**Re: FACADE ORDINANCE - Facade Review – Revised Preliminary S.P.
 Panera Bread Drive Thru Retrofit, PSP12-0047**
 Façade Region: 1, Zoning District: TC-1, Building Area: 468 S.F., 1-Story Addition.

RE: Panera Bread – Drive Thru

Re: **PANERA BREAD DRIVE THRU, JSP12-0048, PSP12-0028**
Preliminary Site Plan and Special Land Use

**PANERA BREAD DRIVE THRU
& BUILDING ADDITION—PHASE 6**

SHEET 2

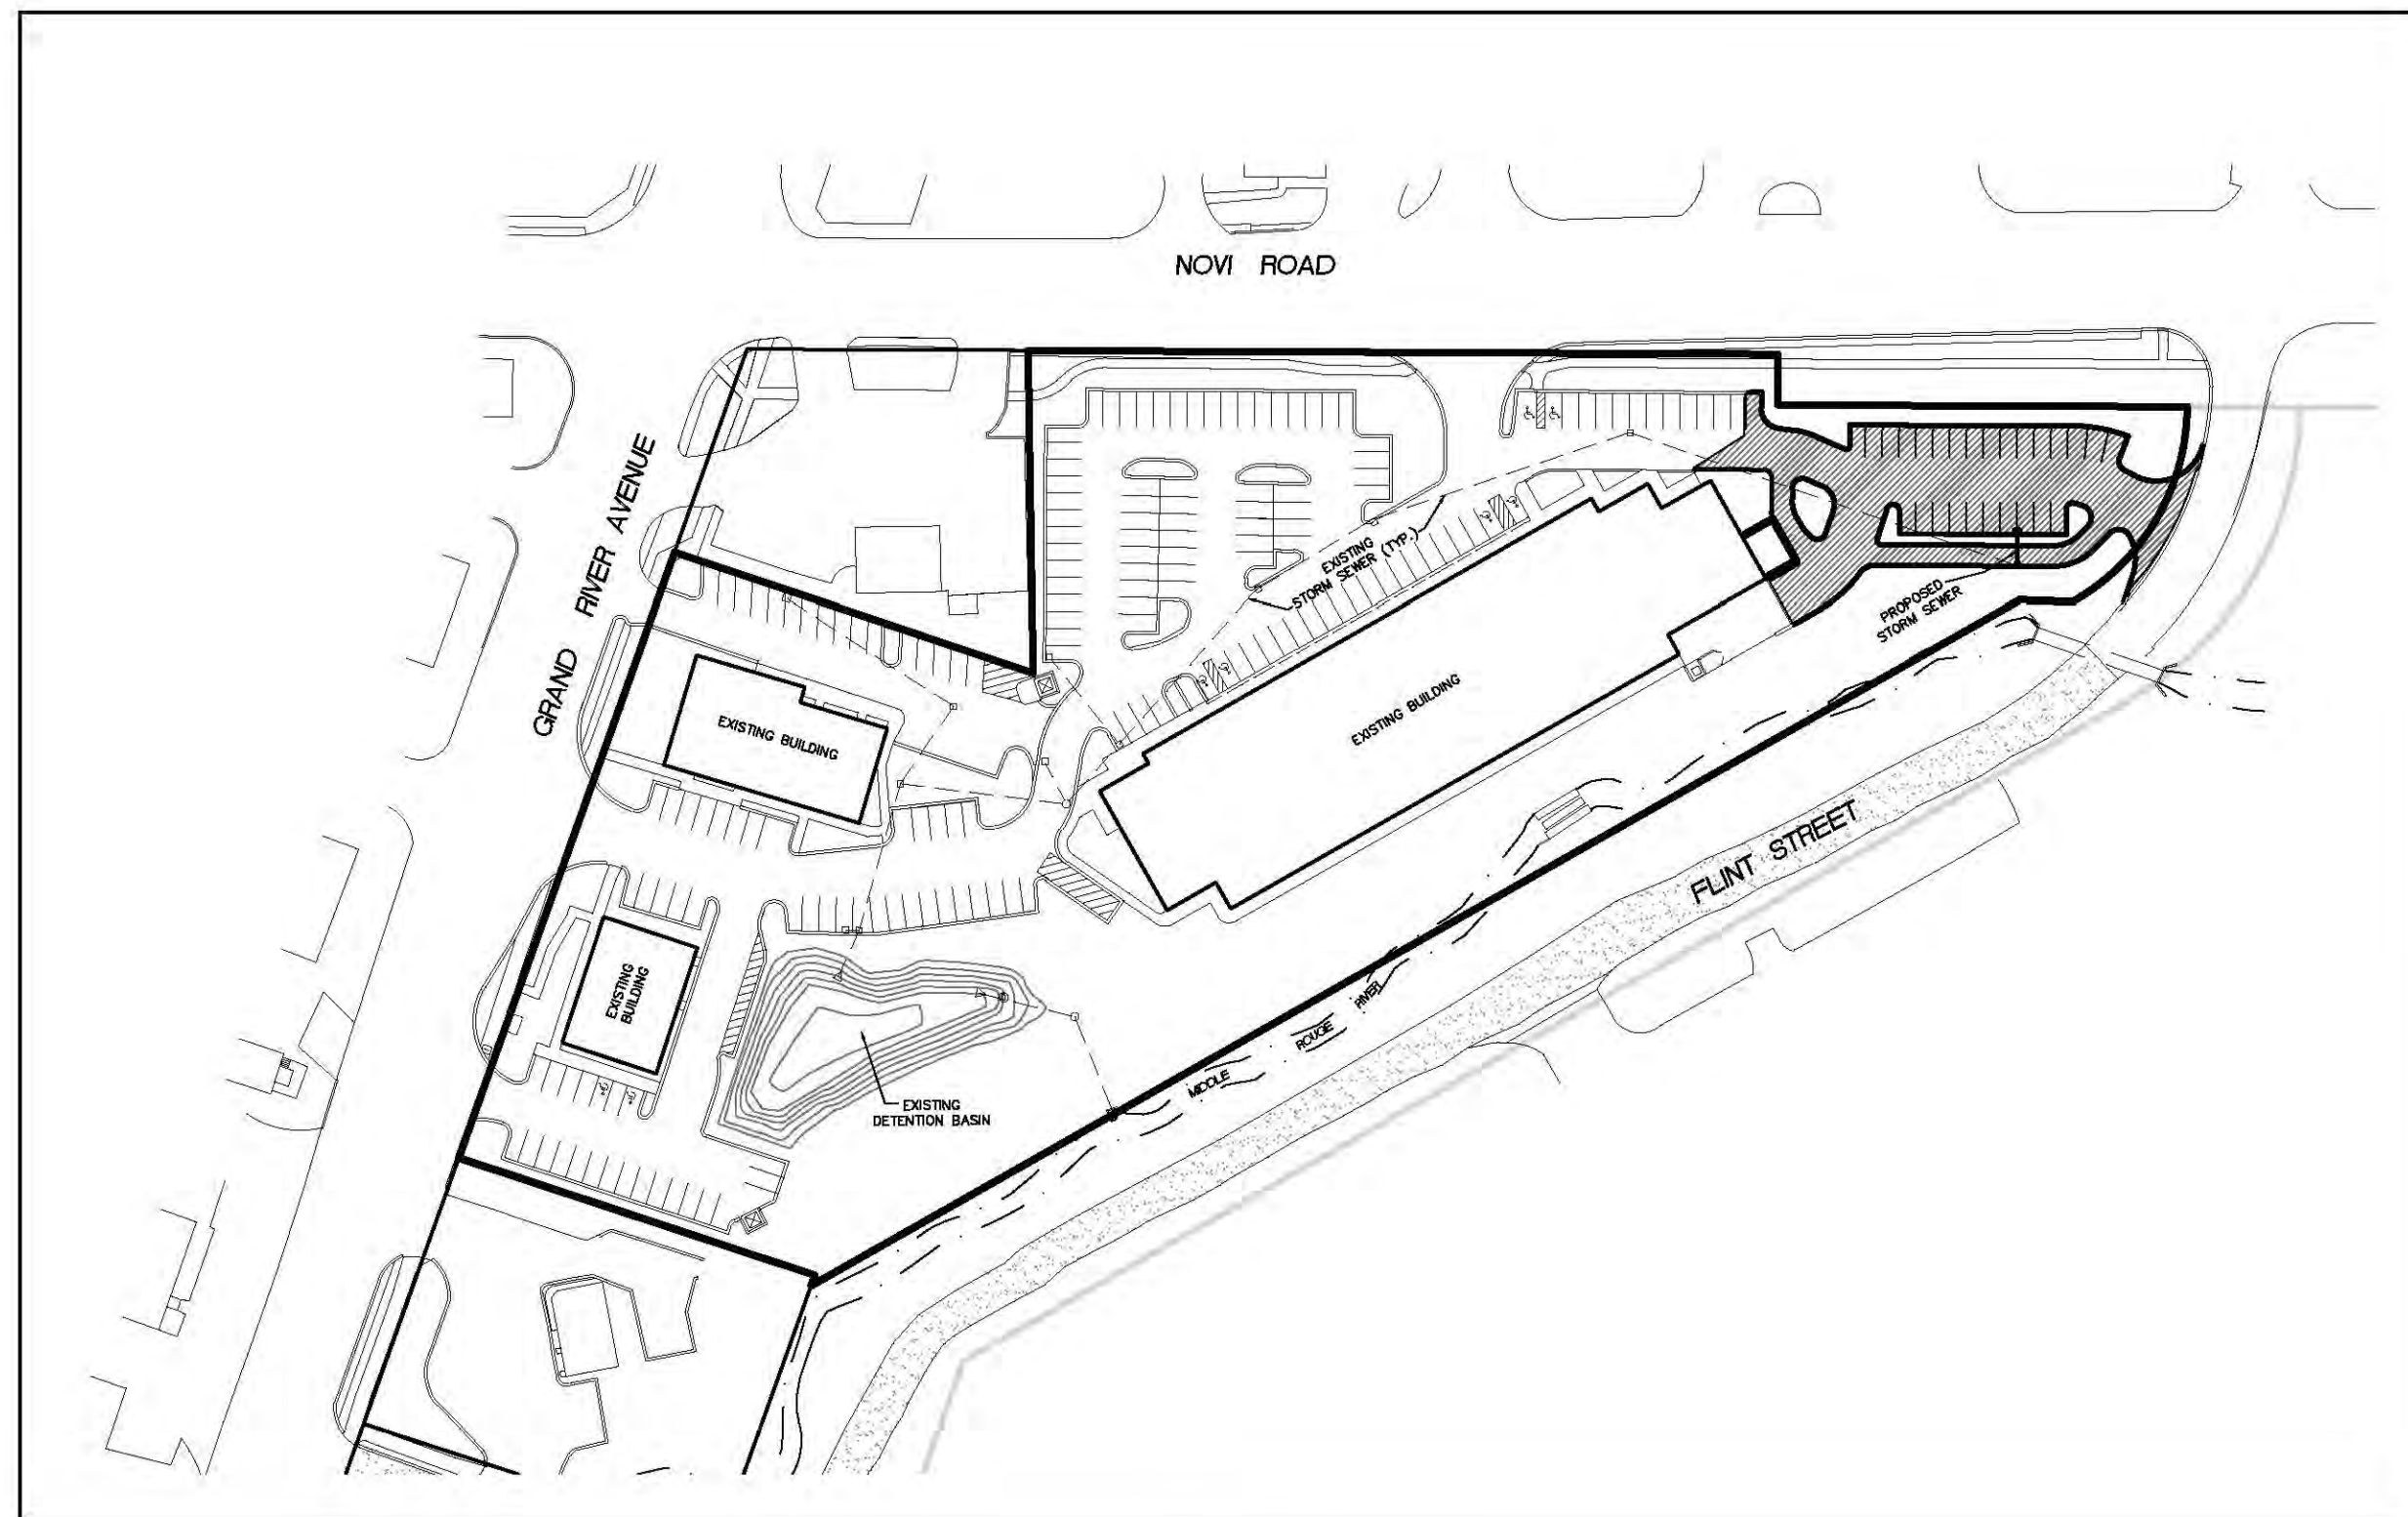
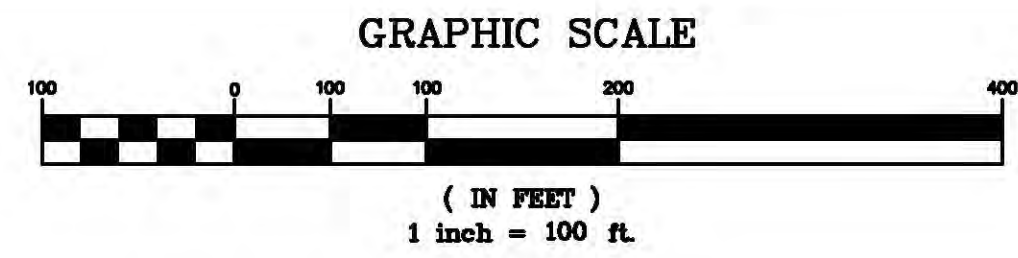
Canopy - A “New Drive Thru Canopy” is indicated on the Site Plan, Sheet 2. No architectural drawings were provided for the canopy. Section 2520.12 of the Façade Ordinance states that canopies are considered separate facades and are to be constructed of materials matching the building. The applicant should submit architectural drawings of the proposed canopy, prior to Final Site Plan Approval. This can be handled administratively, providing that the design is in full compliance. Refer to section 2520.12 of the Façade Ordinance for specific requirements.

Architectural drawings of the proposed canopy will be submitted for review prior to Final Site Plan Approval, as requested.

SHEET NO:
A-2.0
 EXTERIOR ELEVATIONS

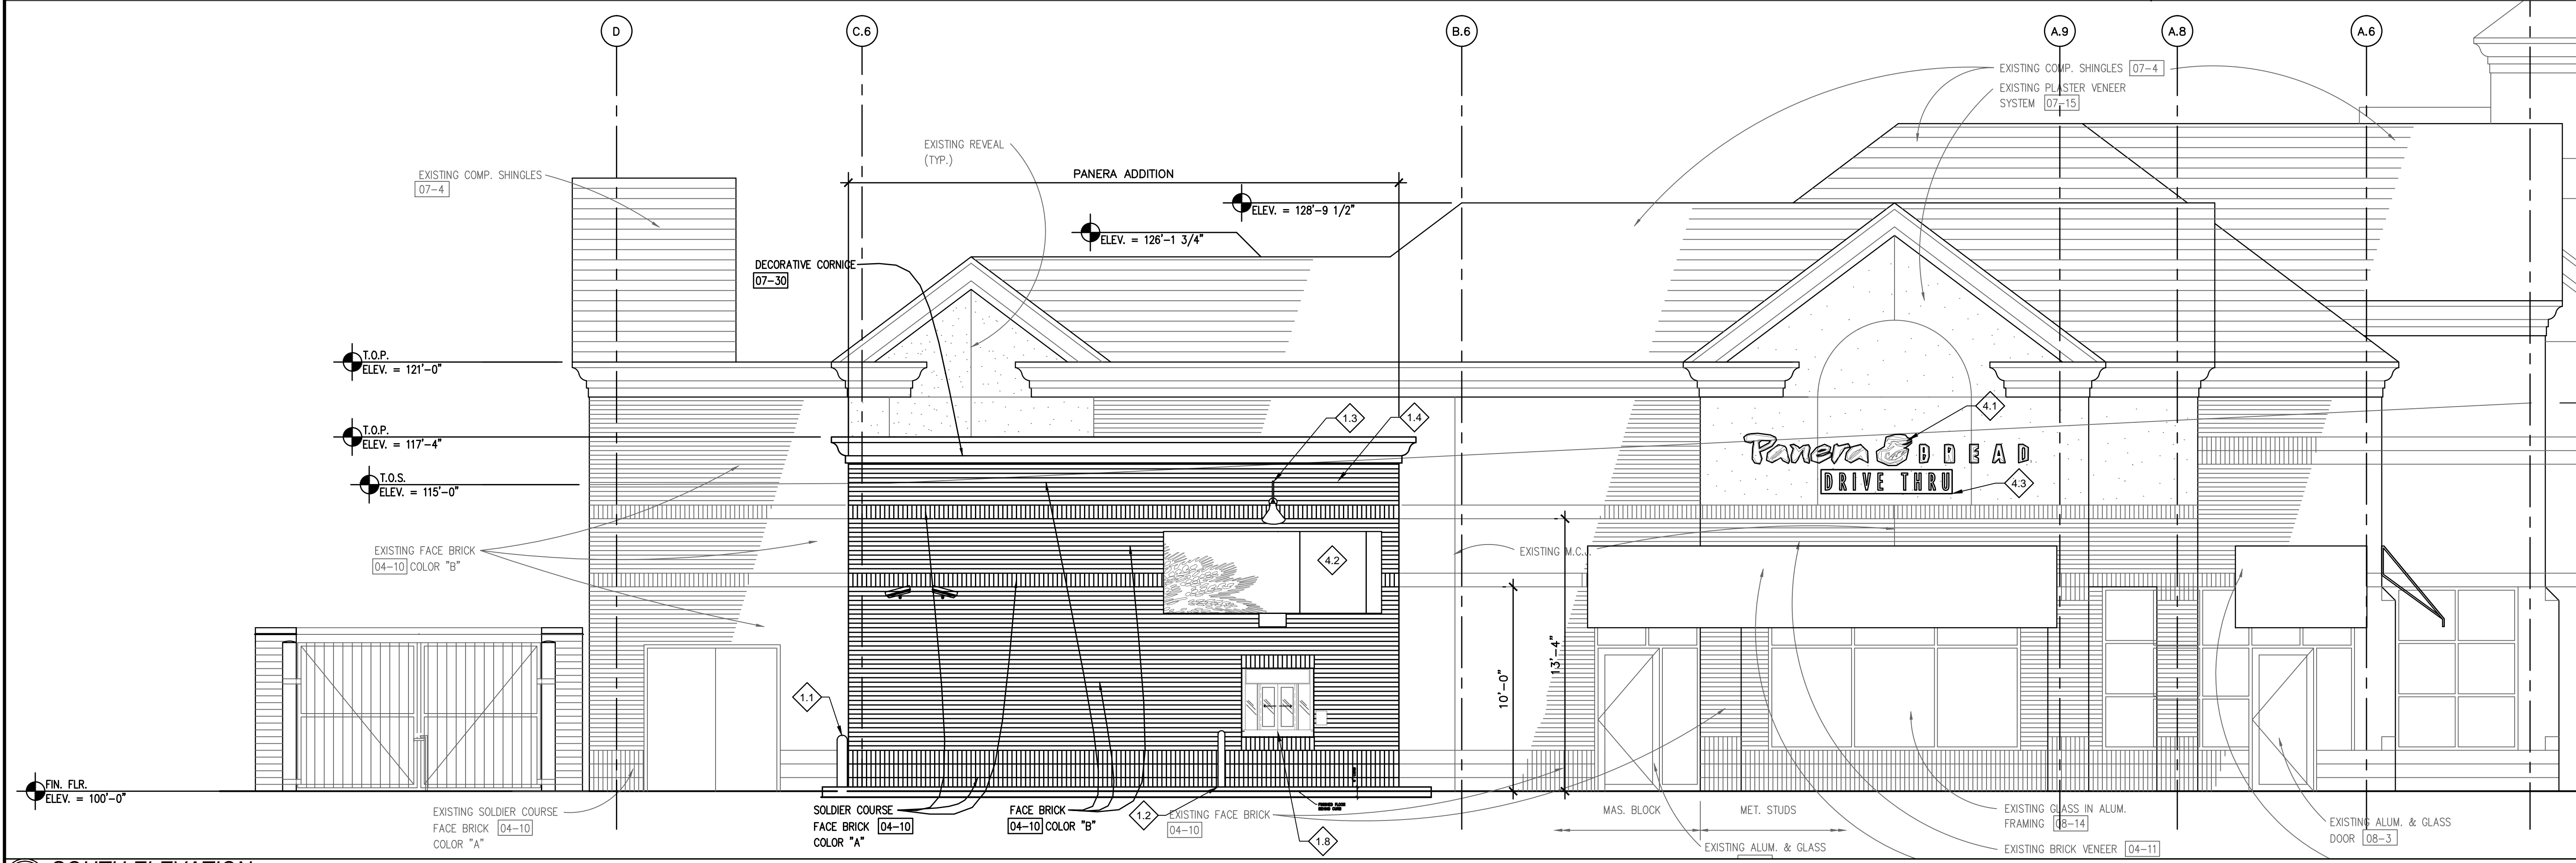
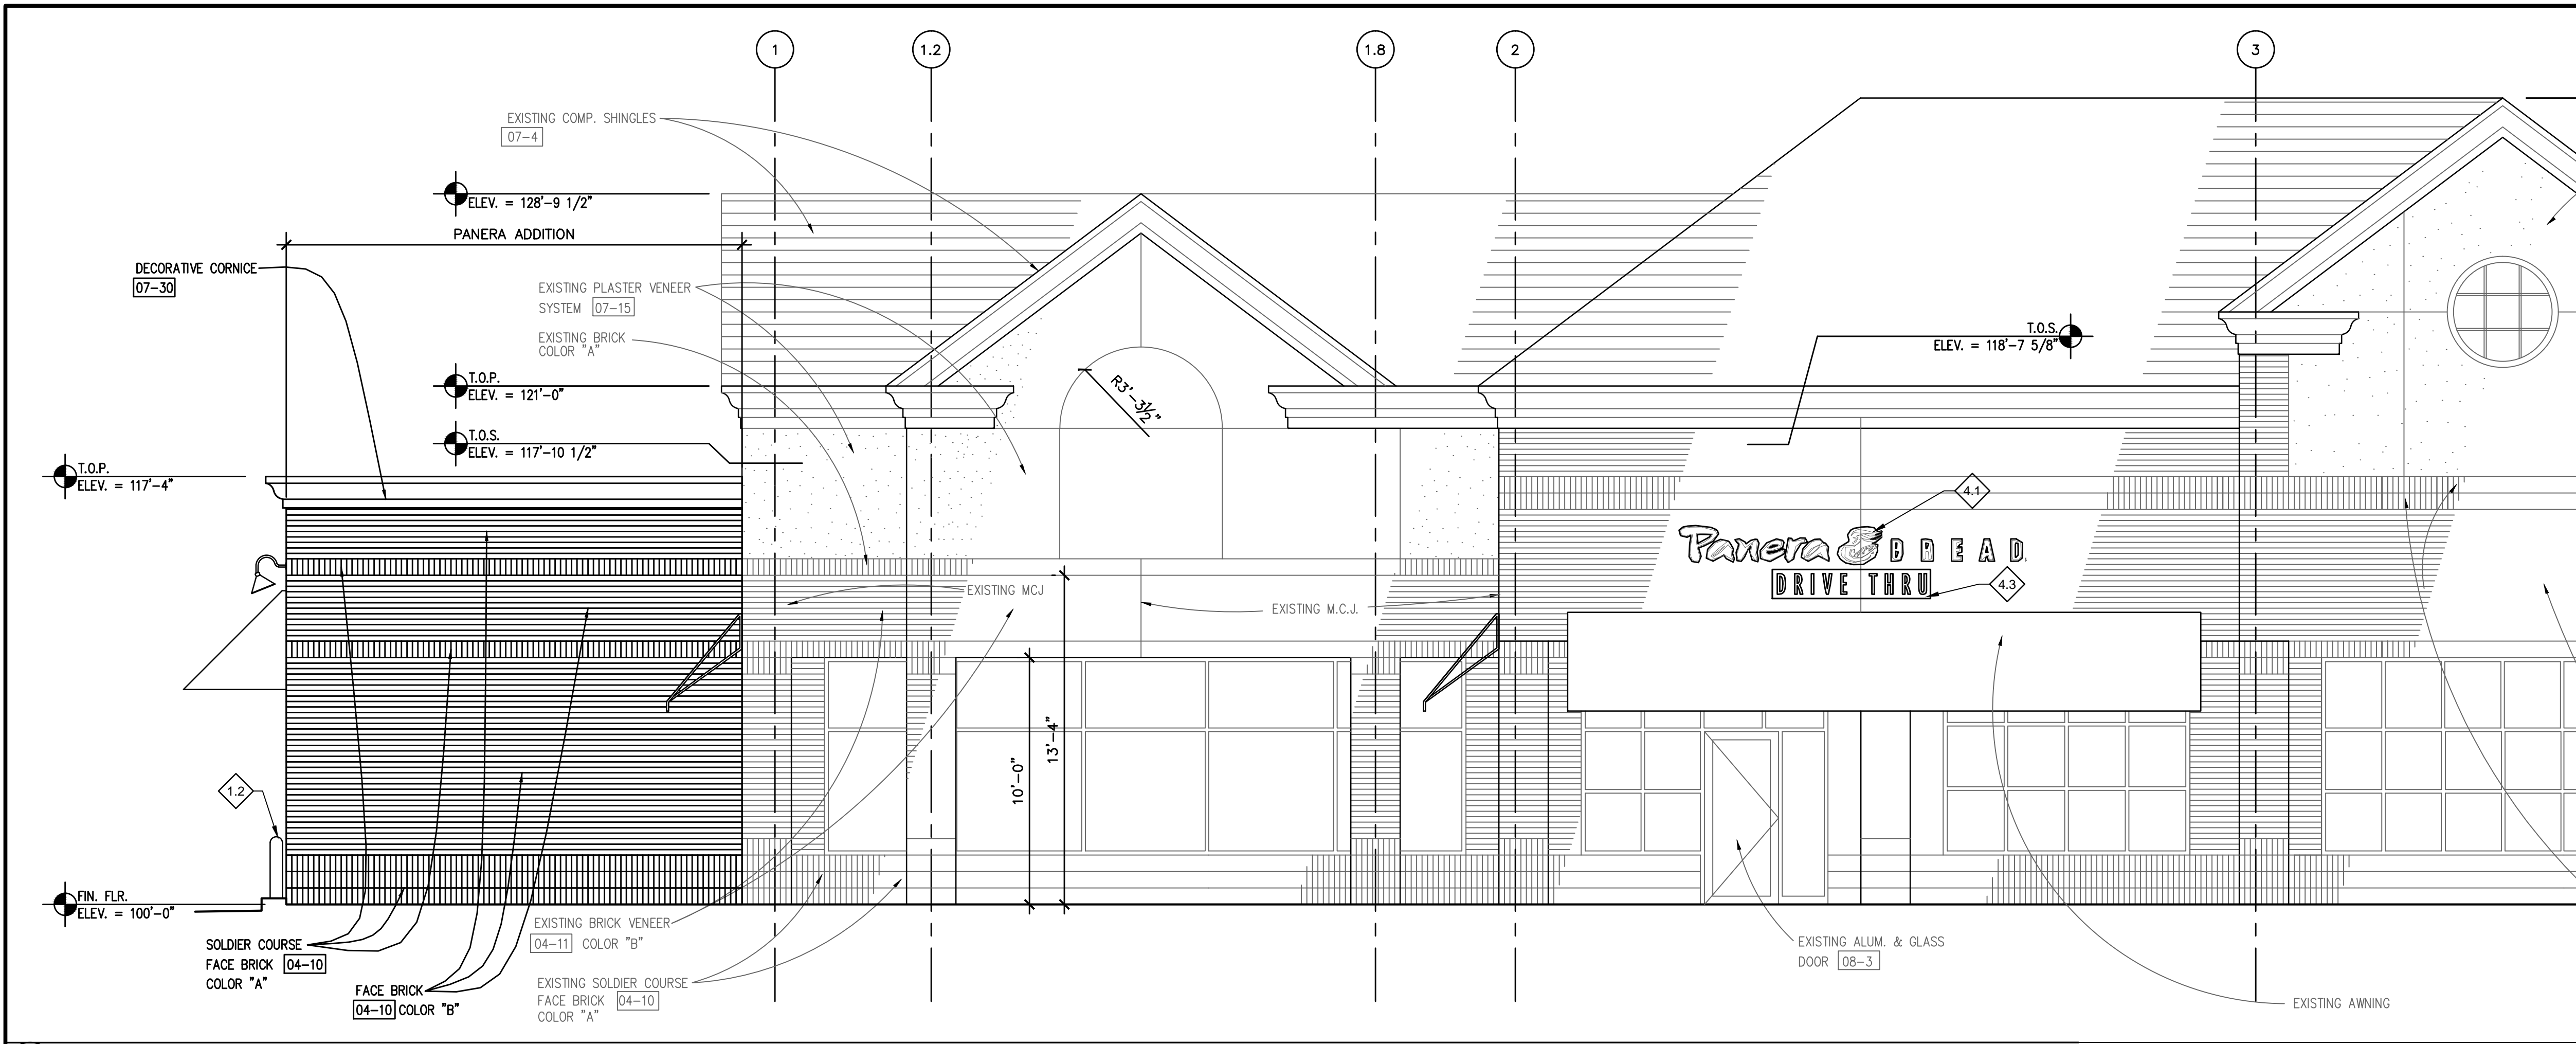
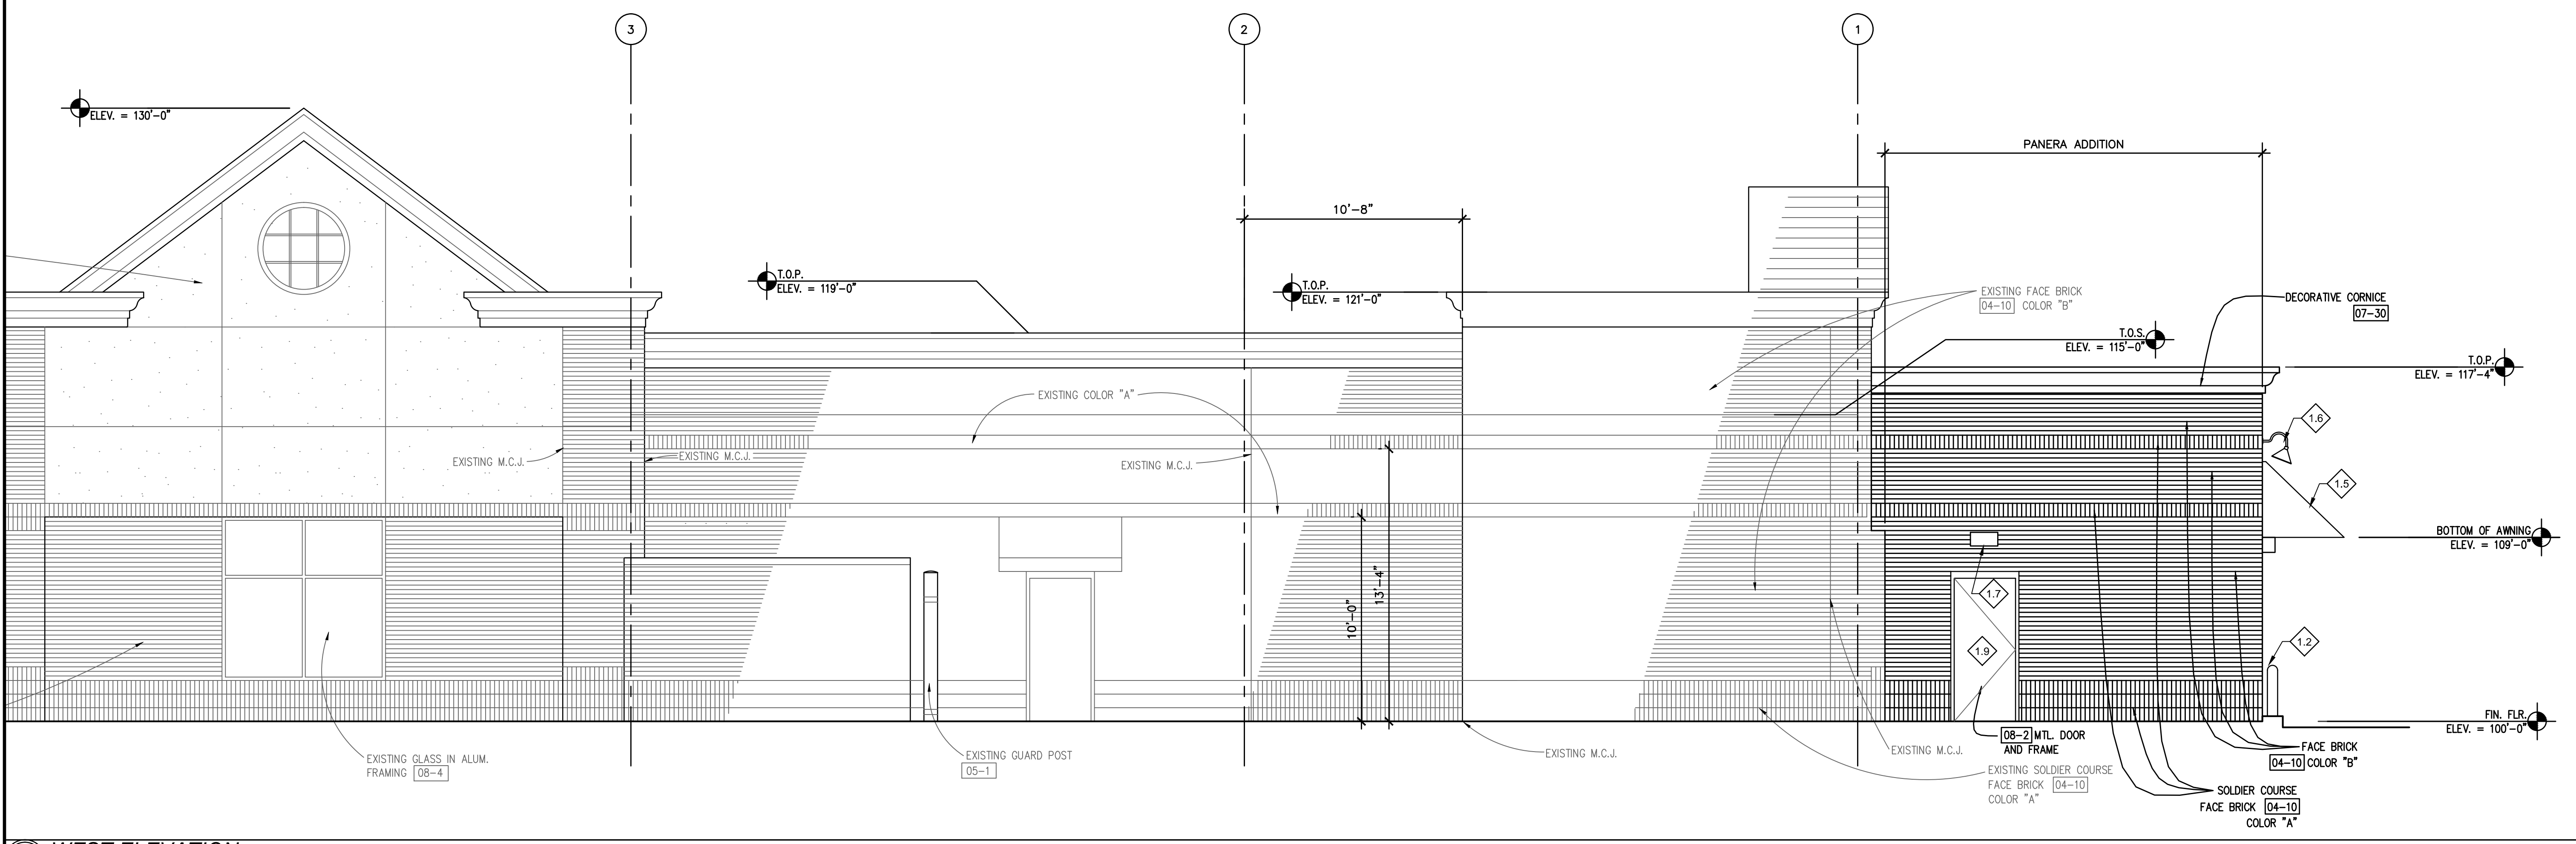
Building - As shown above the percentages of all proposed materials are in full compliance with the Façade Ordinance. A Section 9 Waiver is not required for this project. No façade material sample board was provided however the drawings indicate that all colors are to match existing. It should be noted that Façade Chart footnote 6 requires that the adjacent materials (brick) must extend behind the Fabric Awning.
